PROJECT NARRATIVE

Design - Building

The new building at 50 Webster Ave, on the D3.1 Parcel, advances the revitalization of Union Square in a critical neighborhood location.

PROJECT NARRATIVE
Public Process + Design Review Report

Façade Evolution

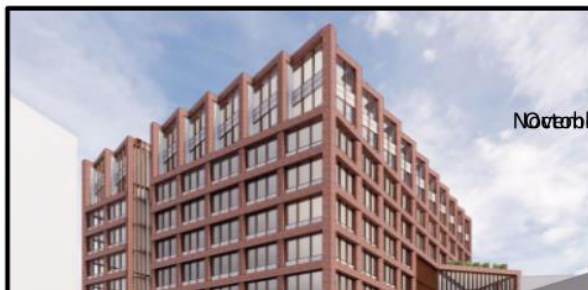
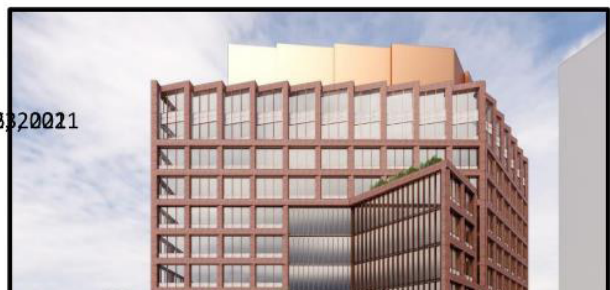
- Penthouse should not be as prominent. Revise penthouse design to be a secondary component of the building and overall have a less imposing effect. Examine using a finer grade for the serrated edges at the top of the penthouse, changing the materiality. Building design included larger penthouse setback along west side of the building, this should be maintained. Penthouse should be set back to minimize visibility from adjacent proposed civic space and sidewalk along the east side of Prospect St and Webster Ave.

- Building materiality needs to be examined further, pursue the use of red brick consistent with what the project team presented at their first UDC design review. Concerns expressed about switching from stone to concrete at the ground floor and tactile quality of textured concrete where people will touch it.
- Proposed cut glass column needs to be developed further. Needs to engage more with the rest of the building and proposed civic space in front.
- Look for opportunities to add additional variation to the long, repetitious north building elevation. Also explore adding screening such as a green wall all or art at the lower level concrete face facing the GLX station.

- Final guidance: Penthouse should not be as prominent. Revise penthouse design to be a secondary component of the building and overall have a less imposing effect. Examine using a finer grade for the serrated edges at the top of the penthouse, changing the materiality. Building design included larger penthouse setback along west side of the building, this should be maintained. Penthouse should be set back to minimize visibility from adjacent proposed civic space and sidewalk along the east side of Prospect St and Webster Ave.

- Final guidance: Building materiality needs to be examined further, pursue the use of red brick consistent with what the project team presented at their first UDC design review. Concerns expressed about switching from stone to concrete at the ground floor and tactile quality of textured concrete where people will touch it.

- Final guidance: Proposed cut glass column needs to be developed further. Needs to engage more with the rest of the building and proposed civic space in front.

- Final guidance: Look for opportunities to add additional variation to the long, repetitious north building elevation. Also explore adding screening such as a green wall all or art at the lower level concrete face facing the GLX station.
- Response: We have studied numerous approaches to interrupting the repetition of the north façade, and find the permanence and intuitive nature of the repetition as providing the most elegant solution. In that the bay-concept maintains origins in the industrial vernacular it is most suited for the project's design concept. Screening concepts and/or green walls will continue to be explored for the optimum lower-level solution.

- Response: The design team understands the laboratory use demands considerable rooftop mechanical equipment and is making all efforts to reduce the visual appearance of the penthouse as the design is refined. As significant coordination is required with various design engineers on the project this work continues through the normal course of project design development. We have studied a finer grade for the serrated edges of the penthouse and found that it actually increased the visibility, competing with serrated top floors of the occupied space, which UDC agreed should be the most visible prominent. We also tried removing the serrations entirely, which increased the visual bulk by removing shadow lines. We believe the proportions and geometry as presented, the middle road between these two options, best ties into the design of the base to make the penthouse feel intentional and considered, without being overly busy and calling attention to itself. We are also looking at a change in the materiality to include perforations at the upper section of the penthouse. The percentage opening needs careful refinement so as not to be overly transparent, but we believe this move will be successful in further reducing the visual height by reducing the vertical scale and softening the top edge.

- Response: The project team believes actual brick as originally conceived will not be able to achieve the crisp and modern three-dimension geometry intended, and that lightweight concrete or a alternative product, abstractly coursed in a brick module dimension, and stained will achieve a modern interpretation of brick. We note this approach was appreciated by some UDC reviewers, who asked that we carefully study the technical aspects of the color and finish to ensure the result is rich in appearance, and durable. We will continue to consider these aspects as the design advances. The ground floor material durability concern is also of import to the design team who will endeavor appropriately satisfy.

- Response: The design team will continue to develop this important design feature in collaboration with team engineers and designers, and glass specialists. As a specialty custom feature, we believe this will require some additional research and development, including mockups, to ensure it is beautiful and engaging both day and night. The type of glass, its detailing, and its lighting is critical here. As the methods develop, we will ensure the feature engages the rest of the building language gracefully, and has the proper presence from the plaza and street.
